SUBJECT: ORDER FOR MODIFICATION OF LICENSE CONCERNING PRIMARY COOLANT
SYSTEM PRESSURE ISOLATION VALVES

ORDER FOR MODIFICATION OF LICENSE

SAFETY EVALUATION REPORT
DAVIS-BESSE NUCLEAR POWER STATION (UNIT 1)
PRIMARY COOLANT SYSTEM PRESSURE ISOLATION VALVES
(WASH-1400, EVENT V)

PRIMARY COOLANT SYSTEM PRESSURE ISOLATION VALVES

Figure 1. Valve Configurations Designated by the NRC To Be Included in This Technical Evaluation

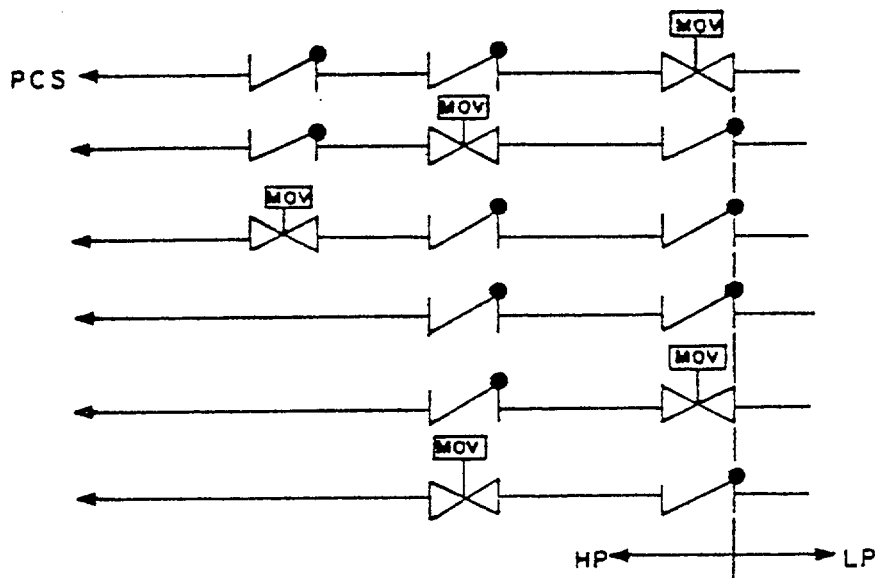
- 1) The high-pressure system must be connected to the Primary Coolant System;
- 2) there must be a high-pressure/low-pressure interface present in the line;
- 3) this same piping must eventually lead outside containment;
- 4) the line must have one of the valve configurations shown in Figure 1; and
- 5) the pipe line must have a diameter greater than 1 inch.

The Decay Heat Removal System (DHR) is composed of two piping trains, each connected directly to the reactor vessel. Each train has two check valves and a motor-operated valve in one of the series configurations of concern. In each train the high-pressure/low-pressure interface is located on the upstream side of the motor-operated valve (MOV). These valves are listed below:

- high-pressure check valve, CF-30
- high-pressure check valve, DH-76, locked open
- high-pressure MOV, DH1A, normally opened

- high-pressure check valve, CF-31
- high-pressure check valve, DH-77, locked open
- high-pressure MOV, DH1B, normally opened

If TEC modifies the Plant Technical Specification for Davis-Besse Unit 1 to incorporate periodic testing, as delineated in Section 2.2, for the check valves itemized in Table 1.0, then FRC considers this an acceptable means of achieving plant compliance with the NRC staff objectives of Reference 1.

<u>SYSTEM</u>	<u>VALVE NUMBERS (b)</u>	<u>MAXIMUM ALLOWABLE LEAKAGE (a)(c)</u>
1. Decay Heat Removal	CF-30	\leq 5.0 gpm
2. Decay Heat Removal	CF-31	\leq 5.0 gpm
3. Decay Heat Removal	DH-76	\leq 5.0 gpm
4. Decay Heat Removal	DH-77	\leq 5.0 gpm
